# GreenStar™ Software Update 2015-2

## Release Notes

## GreenStar™ 3 2630 Display: Display, AutoTrac™, John Deere Section Control, John Deere Machine Sync, John Deere Implement Detection, John Deere Wireless Data Transfer

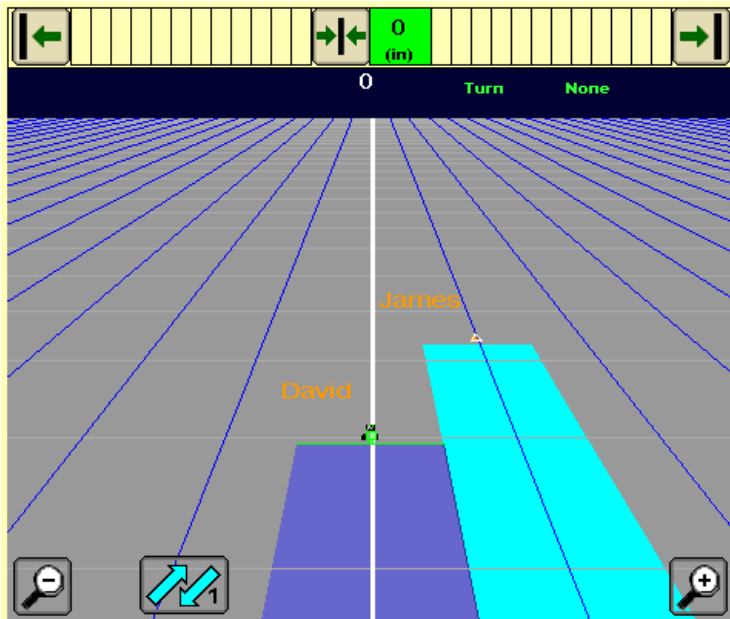
**John Deere Machine Sync Improvements: My Name on Network** – The Name on Network input box has been added to the Machine Sync Shared page for easier access when using Machine Sync for coverage map and guidance line sharing.

**John Deere Machine Sync Improvements: Name on Network** – The Name on Network shows up to 5 characters on the Mapping Pages. Previous software versions limited this to only 3 characters.

**Shared Coverage Status**

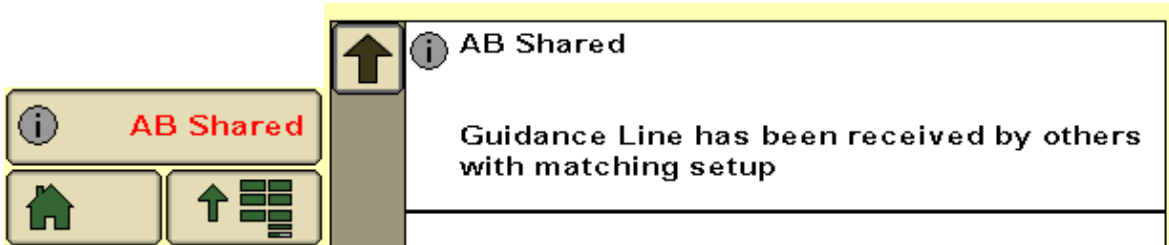
**John Deere Machine Sync Improvements: Shared Coverage Status** – Selecting the status indicator will open the Shared Coverage Status page. This page lists the runtime status of all machines that the GS3 2630 Display is communicating with, their Name On Network, and the time the machine last received shared coverage (Last Synced). The Question Mark button will show the Runtime Status Key descriptions.

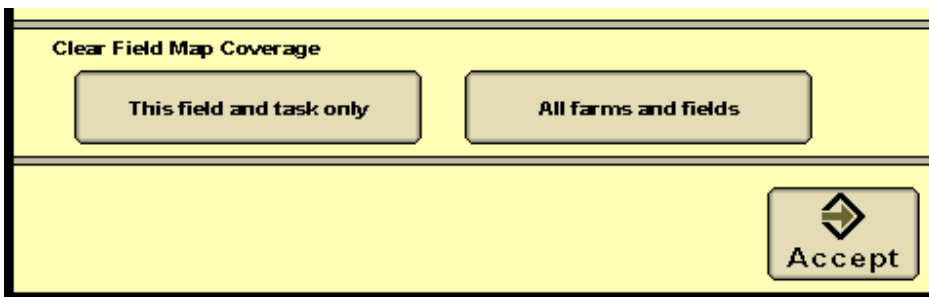
**John Deere Machine Sync Improvements: Guidance Line Sharing** – After pressing the Share AB Line on the Set Track 0 page, the Message Center text will be updated and will show AB Shared or AB Failed. The Message Center will now also explain additional message details.

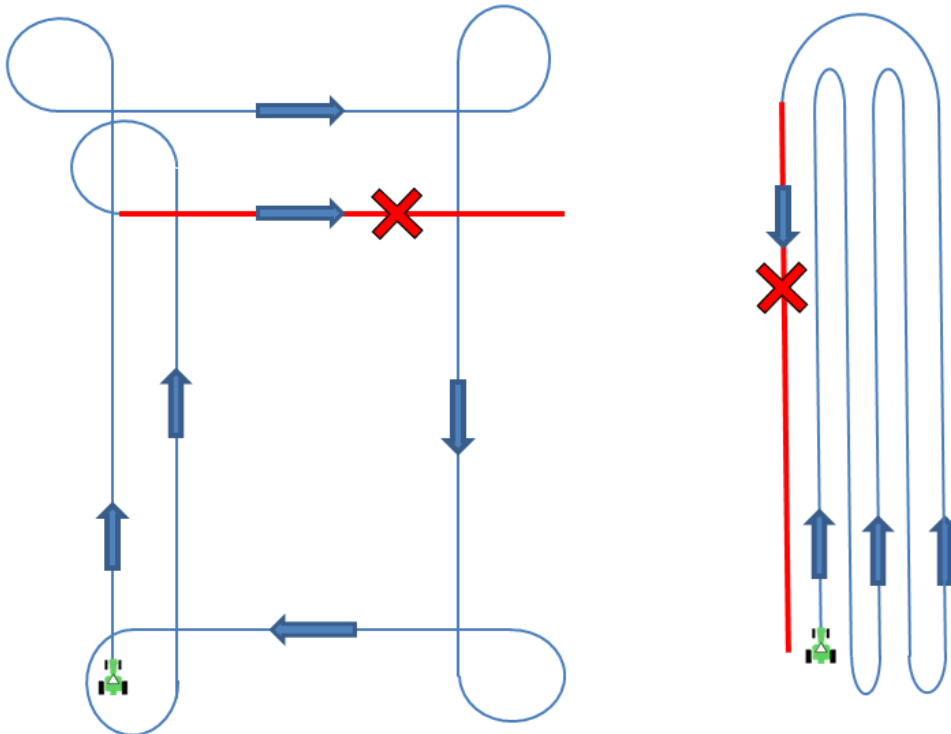
**Mapping: Map Settings** – When creating and deleting operations, the Map Settings Foreground list would not update to remove deleted operations.
